The Clarifier

On May 12, 2022, JIG issued *Operations Bulletin 143 – Filtration Update & TN11* [JIG Bull. 143 & TN11](#) to remind users of the requirements included in the new *Issue 13 JIG Inspection Checklist* to establish a risk-based Management of Change plan specific to each location at which they operate to establish what actions are required to phase out Filter Monitors (FM) from their operations. It is also recommended to establish a site-specific Transition Plan containing a schedule under which FMs will be replaced.

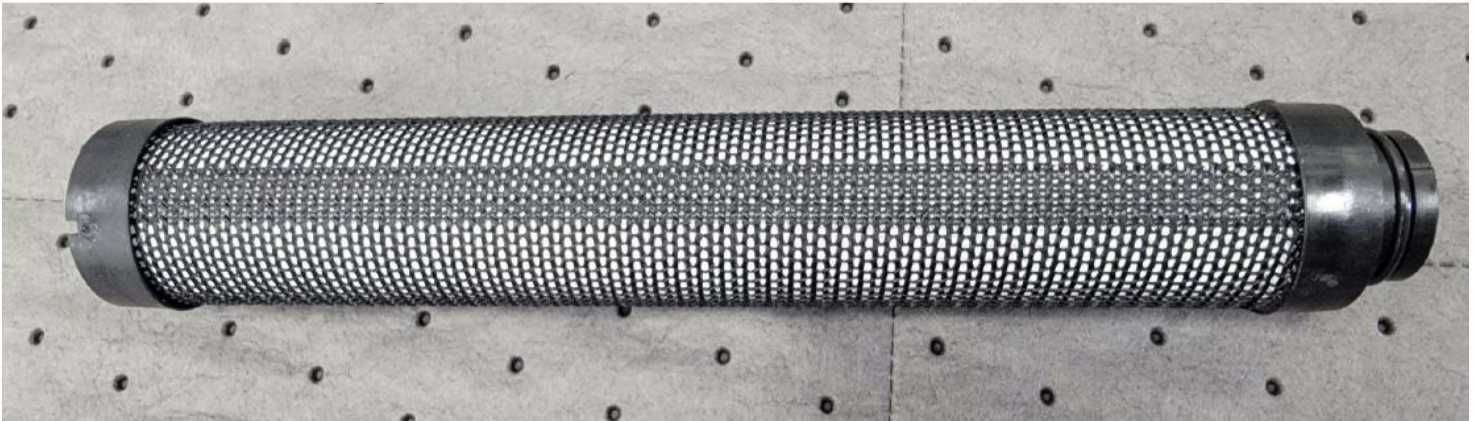
The photo below shows 2" monitor elements, 2" dirt defense filters and our CDFX element at a JIG location. Can you spot the difference? Therein lies the problem! We want to make it absolutely clear to maintenance personnel, operators and inspectors which element is being installed. When our CDFX-2xB is qualified later this month, CDFX will have a black outer sleeve to distinguish it from all elements that appear similar.

The photo above shows our new CDFX-2xxB with the black outer sleeve to distinguish it from elements that appear similar. We also redesigned the seam of the outer sleeve, so we now have a much improved – low profile seam.
